Bridle Gate Project

Final Revised Environmental Impact Report

Prepared for
The City of Brentwood

August 2023

Figure 1-1
Revised Vesting Tentative Map

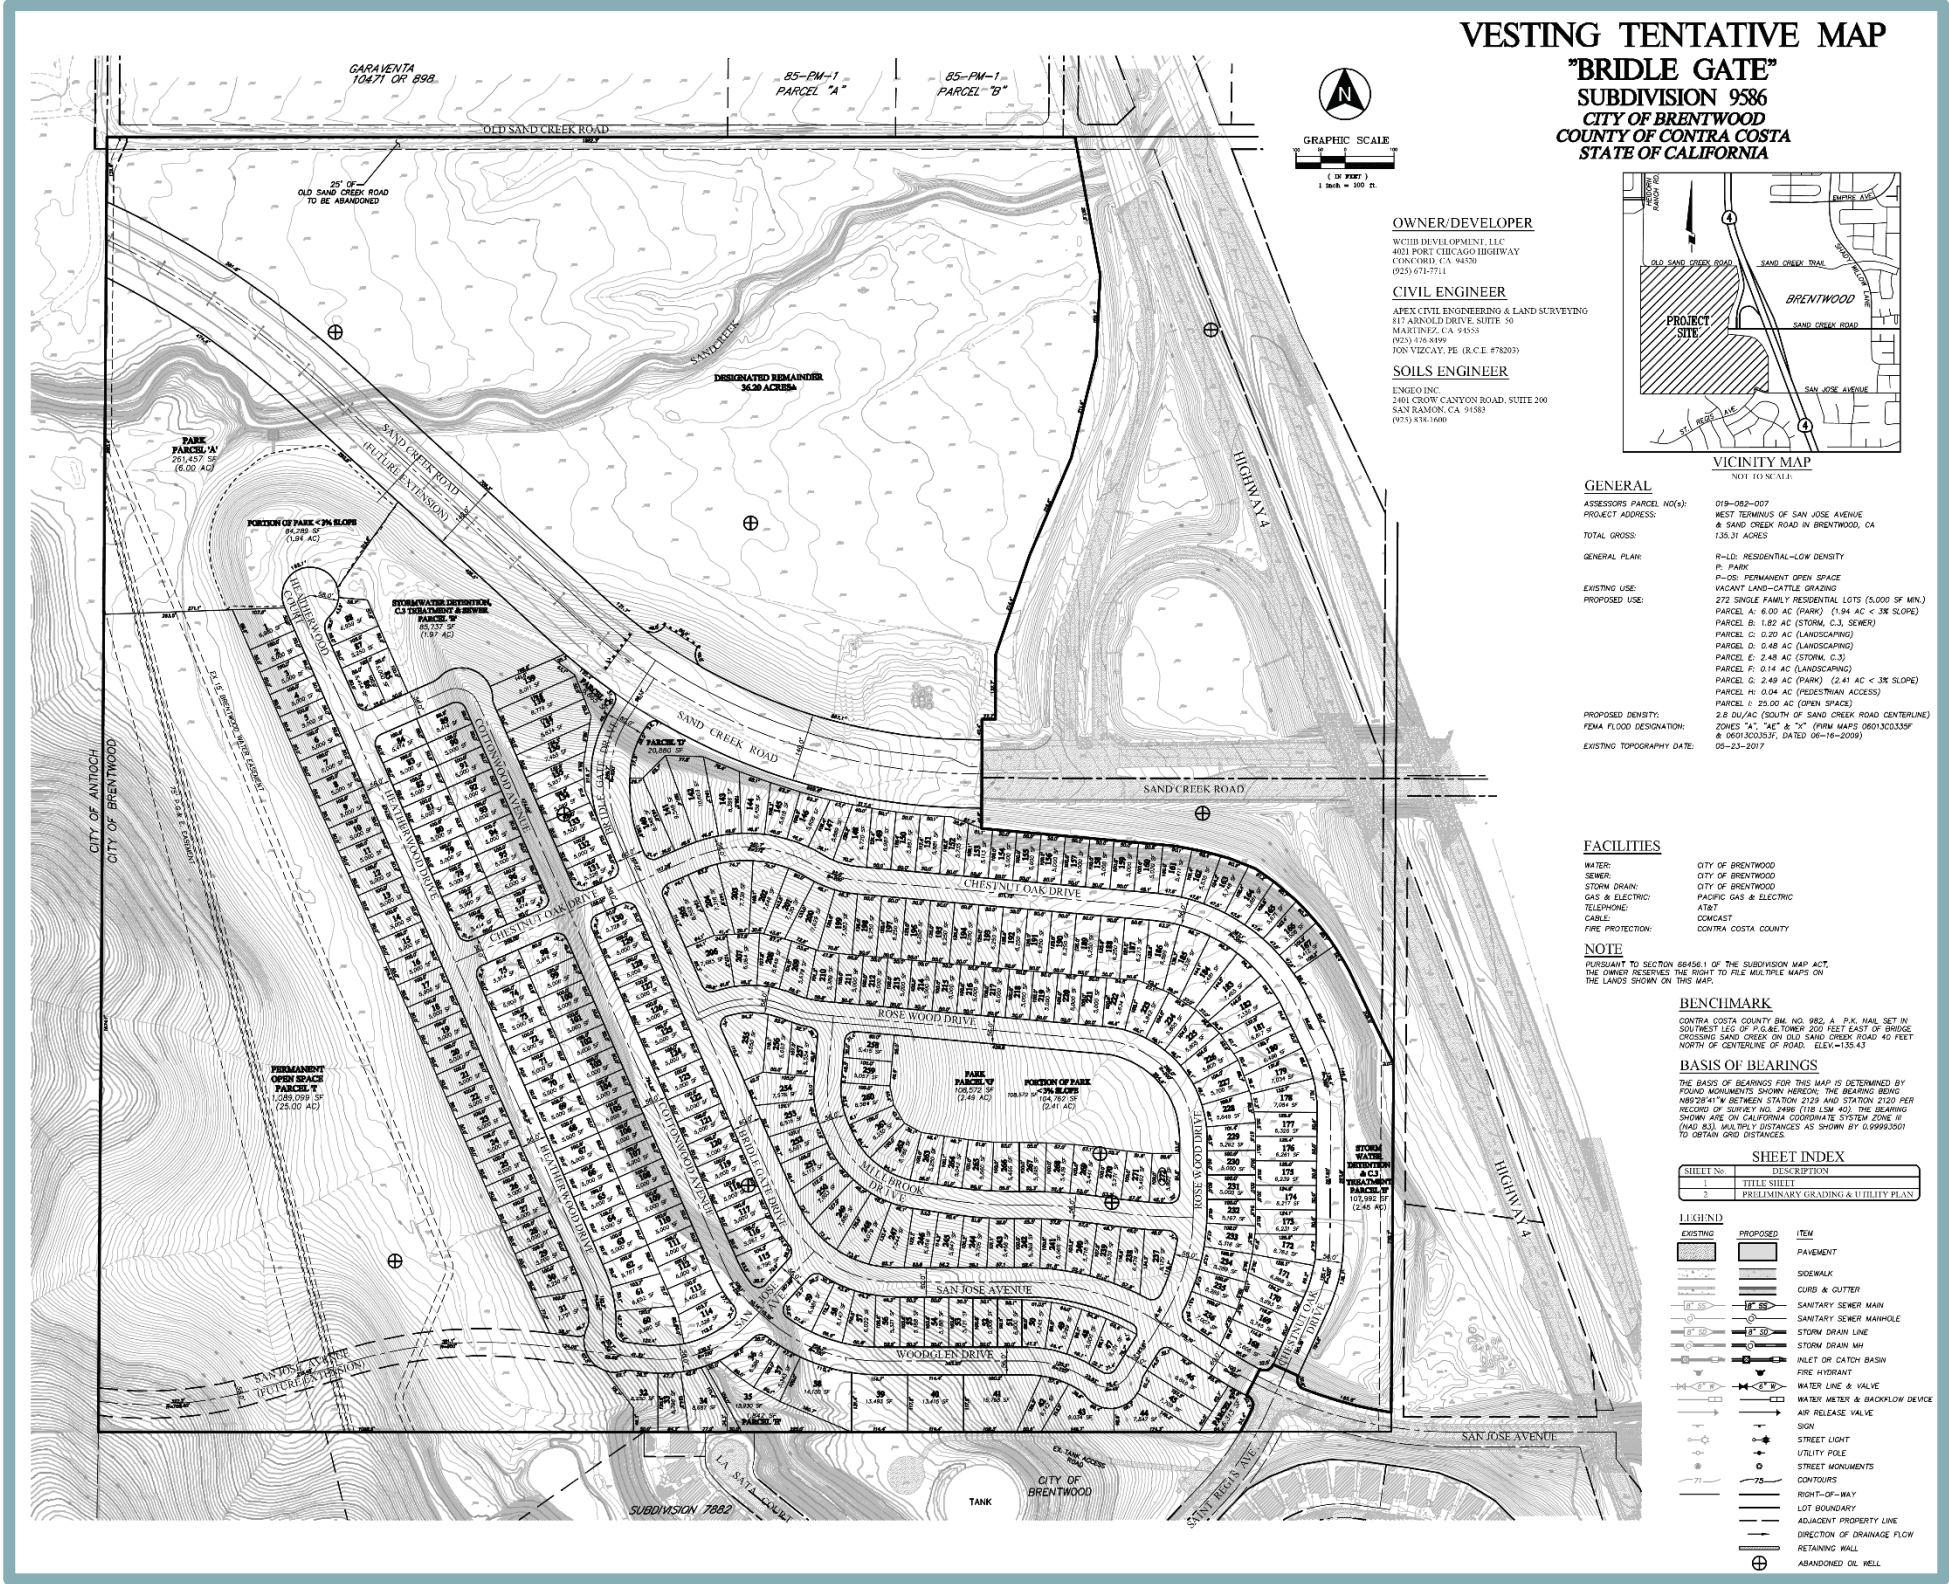
Since release of the Draft REIR, the applicant has provided a revised tentative map to comply with the applicable development standards for PD-36, Subarea C, which are set forth in BMC section 17.486.004, including a minimum lot size of 5,000 sf. This resulted in a reduction in the number of lots from 286 to 272, and remains consistent with the General Plan designation (see Figure 1-1).

In addition, as shown on Figure 1-1, Millbrook Court, which was previously located east of Park Parcel G was reconfigured such that the cul-de-sac has now been extended and the roadway has been renamed Millbrook Drive, which would connect to Rosewood Drive to the north and to the east. Due to the reconfiguration of Millbrook Drive, Park Parcel G has been reduced from 3.39 acres to 2.49 acres. In addition, the lots surrounding Park Parcel G were moved to be located north of Millbrook Drive and south of the park.

**Figure 4.4-3
Transportation Noise Contours on Project Site**

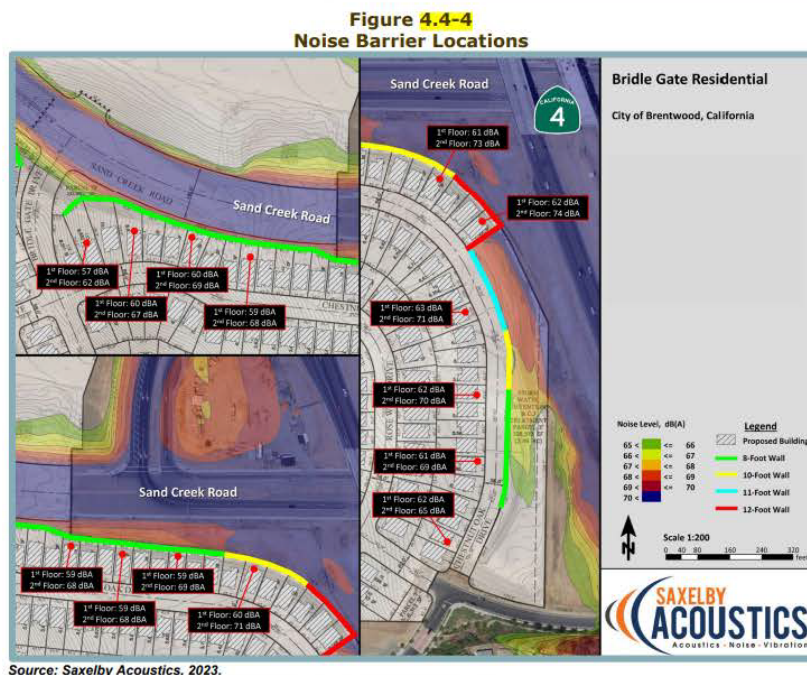
Question 2-Are the proposed sound walls high enough?

Fig. 4.4-3 shows the homes closest to the Route 4 and Sand Creek interchange are expected to have the highest noise.

9-5

Response to Comment 9-5

The comment presents figures from the Draft REIR and does not address the adequacy of the Draft REIR.

Map of capped oil wells on the Bridle Gate land.

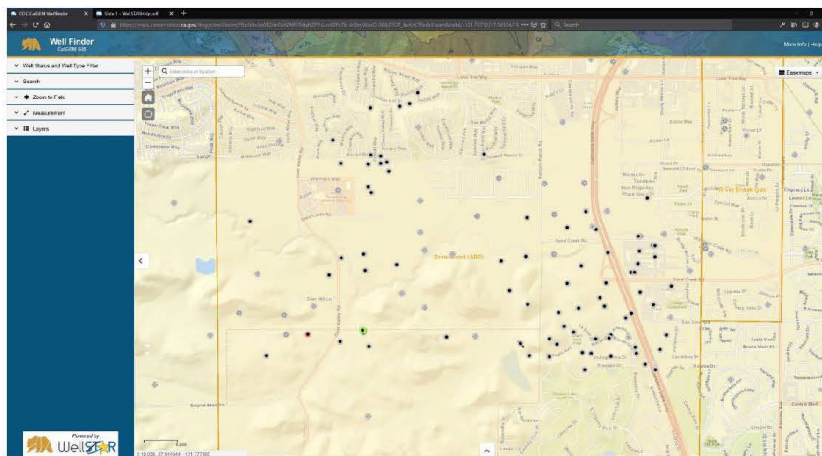
Furthermore, building on capped oil wells is a known public health hazard and is another reason this project should be denied. Not to mention the clearly doctored environmental impact report claiming 288 more homes would only add another 17 cars? Corrupt and ridiculous.

Response to Comment 36-4

The project would be required to comply with Mitigation Measure 4.3-2, which would require proof to the satisfaction of the City Engineer that all planned development on-site is at least 10 feet from any abandoned oil wells, and that any abandoned oil pipelines within the project site are removed in consultation with the Contra Costa County Environmental Health Department. Compliance with Mitigation Measure 4.3-2 would reduce the potential for a significant hazard to the public or the environment through reasonably foreseeable upset and accident conditions involving the release of hazardous materials into the environment to a less-than-significant level.
